Technical Note

Project:	Adamstown Station Phase 3 - Block ACD		
Subject:	Block ACD - Roads and Transport RFI response		
Author:	Peter Foley		
Date:	08/09/2022	Project No.:	5150924
Atkins No.:	5150924DG0112		
Distribution:	SDCC and Design Team

Figure 1: Currently proposed and previously submitted footpath on West Street.

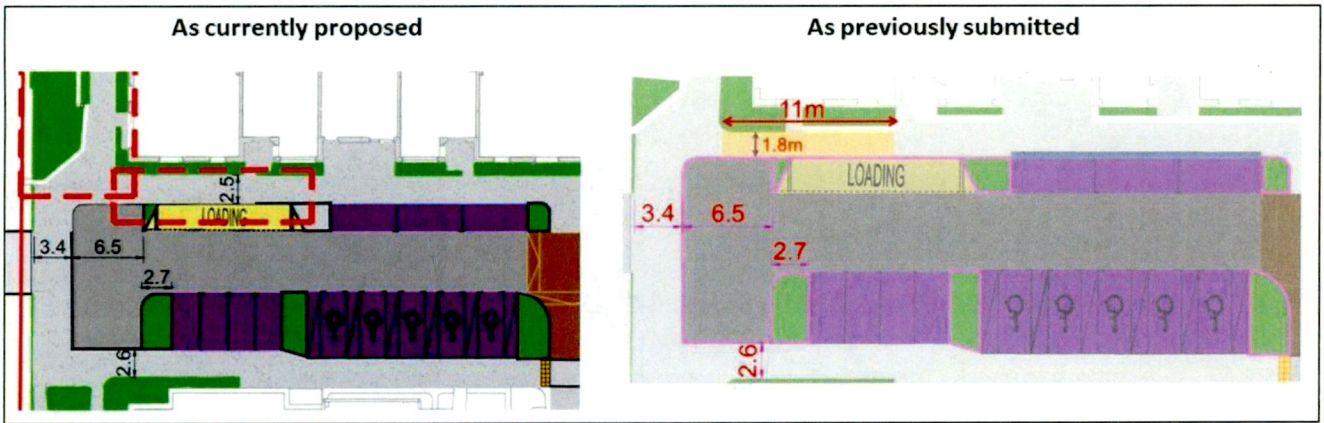
“The applicant is requested to submit a revised layout not less than 1:200 scale showing the minimum width of footpaths at 2.0m wide.”

All footpaths within the demise of the application are a minimum of 2m. Please refer to drawing 5150924-HTR-08-DR-0101 Rev C for details.

On the previously submitted Block ACD application on a small section of West Street the footpath was reduced to 1.8m to provide defensible space to a ground floor residential unit. This has been revised for the current submission. The previously submitted and currently proposed images are shown in Figure 1 for ease of reference.

Figure 3: Internal changes to undercroft to incorporate improved access to parking

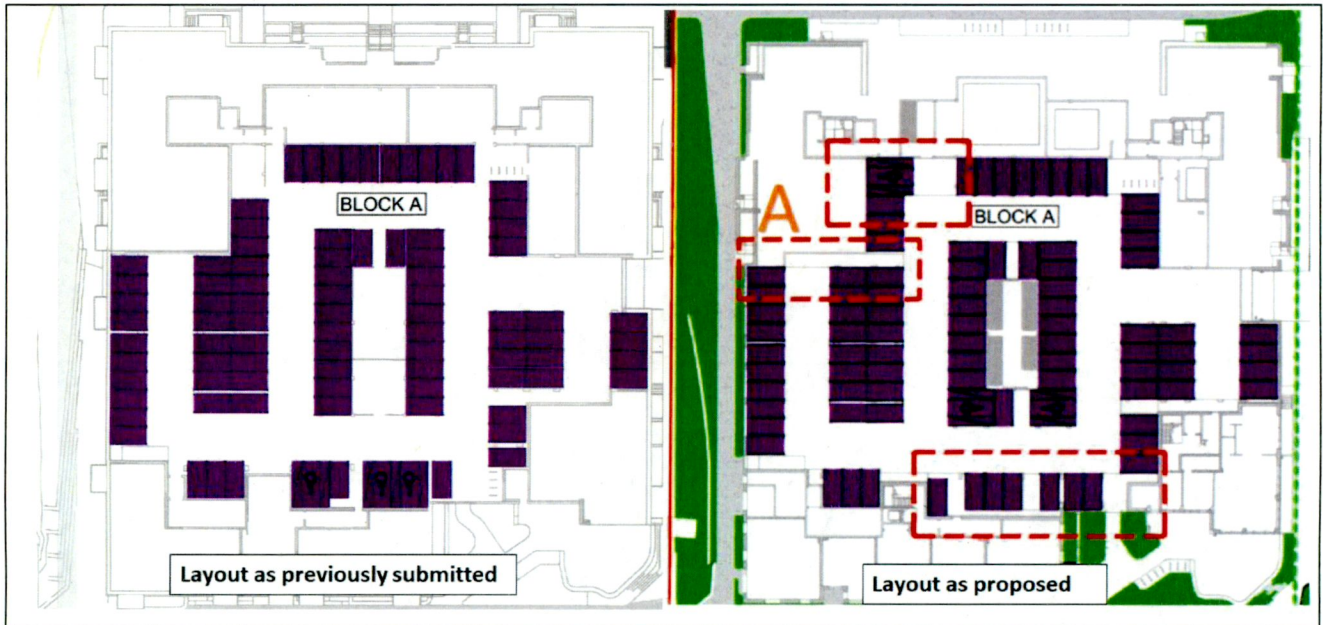
"The applicant is requested to submit a revised layout not less than 1:200 scale showing a turning location at the dead end in the car park of Block A, as per road safety audit."

The internal layout of the undercroft has been amended as part of the RFI response as shown in Atkins drawing 5150924-HTR-08-DR-0101 Rev C. The changes between the submitted and now proposed are highlighted in Atkins drawing 5150924-HTR-08-SK-0047, an extract of which is shown in Figure 3. This includes a corridor behind the dead-end area (see A on Figure 3) that facilitates additional space to allow cars to manoeuvre into and out of these spaces. Atkins drawing 5150924-HTR-08-SK-046 shows vehicle tracking that shows these end spaces are accessible.

Figure 4: Crossing facilities on West Street

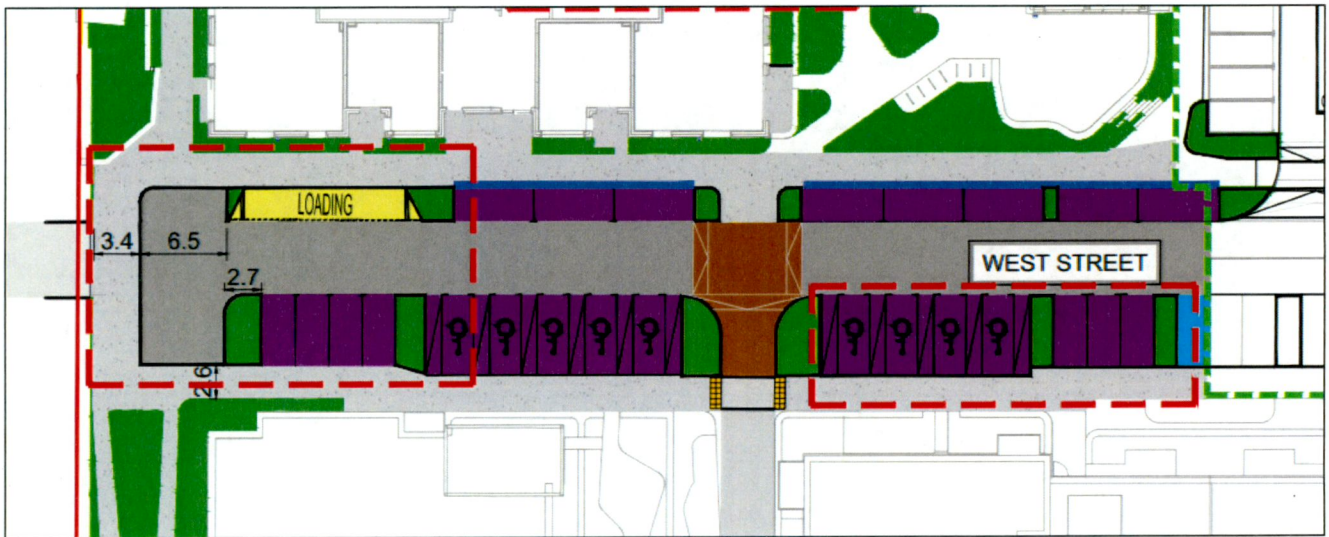
“The applicant is requested to submit a revised layout not less than 1:200 scale showing pedestrian crossing locations along the West Street, as per road safety audit.”

Atkins road and transport layout drawing 5150924-HTR-08-DR-0101 Rev C shows revision to West Street to provide enhanced pedestrian facilities along the western boundary adjacent to the Farmers Bridge. The turning head has been adjusted eastwards to provide a wider pedestrian path. Central location on West Street is a raised crossing that provides a clearly defined crossing picking up on the desire line between Block C & D. To the east of west street, the north-south pedestrian desire line and associate crossing facilities has been provided as part of previous granted planning permission for Block B&E. Figure 4 shows an extract of the crossing provided.

Figure 6: Visitor set down parking spaces on Station Road.

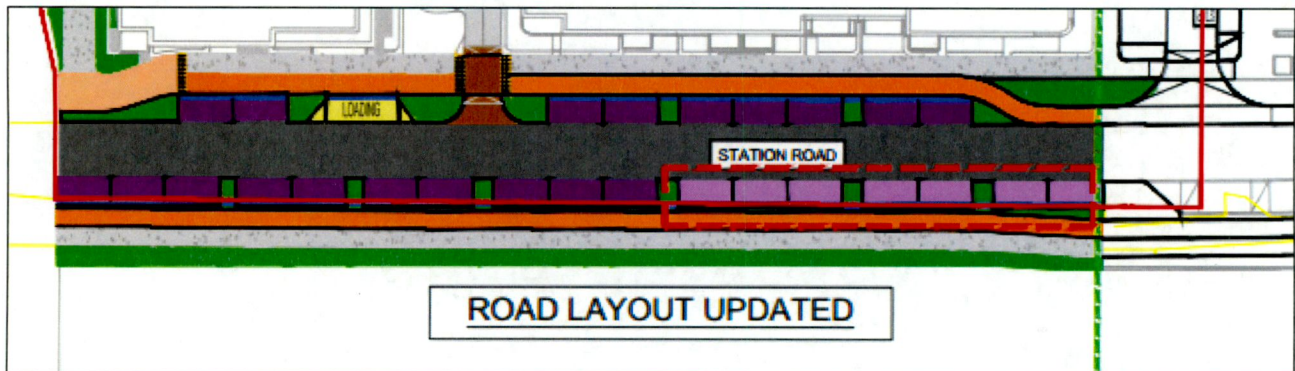
"The applicant is requested to submit a revised layout not less than 1:200 showing 7no. assigned car parking spaces on the south side of the Adamstown station Road as unassigned set-down parking spaces for use at the train station."

Atkins drawing 5150924-HTR-08-DR-0101 Rev C shows revision 7no. car parking spaces on Station Road as set-down parking spaces for use at the train station. An extract is shown in Figure 6.

Figure 7: Overview of cycle infrastructure on Station Tile

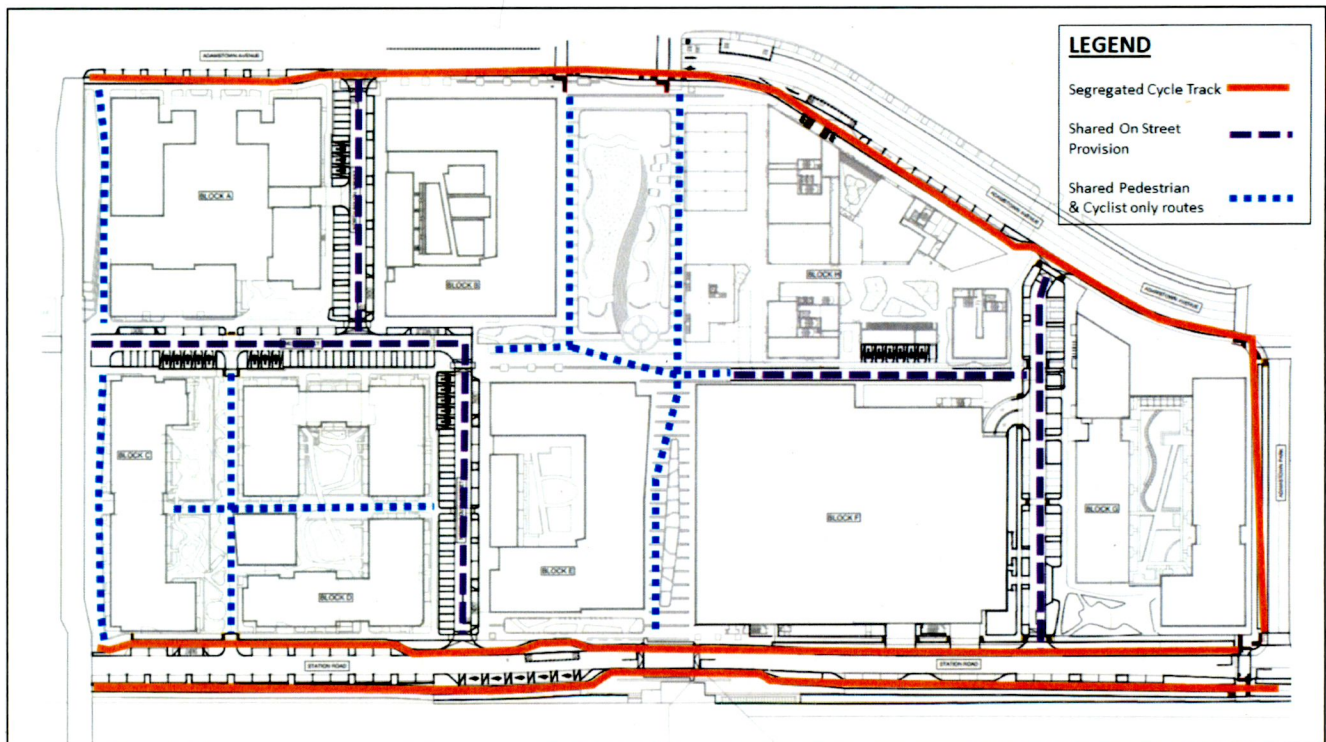
“The applicant is requested to provide details of how the cycle lanes are compliant with the NTA cycle design guide.”

On Avenues within the planning application, (sections of Station Road and Adamstown Avenue), that is higher order functional roads with higher volumes of traffic fully segregated cycle lanes have been provided. The design of these segregated cycle lanes is identical to the previous phase for the Station Tile including the agreed approach along Station Road which was agreed with the National Transport Authority (NTA). While on quieter roads such as West Street the design approach is that cycle facilities are provided in a shared on street provision. In addition to the above there are areas within ACD, such as along Famers Bridge, between block C&D where there is shared pedestrian and cycle routes only. This approach is shown in Figure 7 an extract from the Transport Statement submitted as part of the planning application.

This approach is consistent with National Cycle Manual Section 1.7 Integration and Segregation.

Figure 9: Bus set down and turning areas provided on Station Road on Boulevard Tile

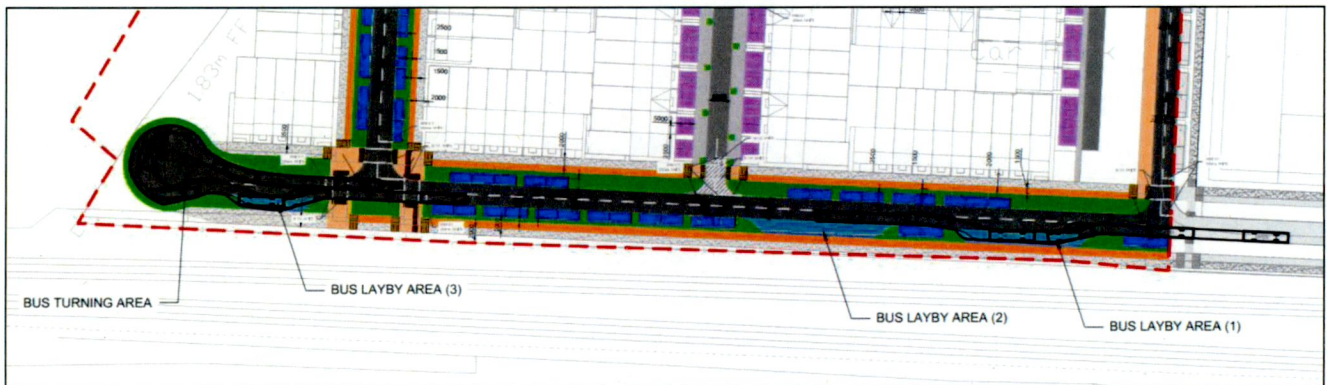
“The applicant is requested to provide details of bus set down areas.”

Bus set down areas and bus turning areas are provided on Station Road on the adjoining Boulevard Tile. Atkins drawing 5150924-HTR-10-DR-0129 submitted as part of the planning application (Ref SDZ22A/0007) for Adamstown Boulevard Phase 1 to South Dublin County Council (SDCC) shows the location of the set down and turning facilities. An extract of this drawing is shown in Figure 9 and a copy of the drawing has been submitted as part of this RFI for information. The 3No. laybys provide capacity for 5 No. buses to set down. This approach was discussed and agreed with SDCC (Roads) and the NTA during formal pre-application discussion for Boulevard Masterplan and Phase1 planning application.
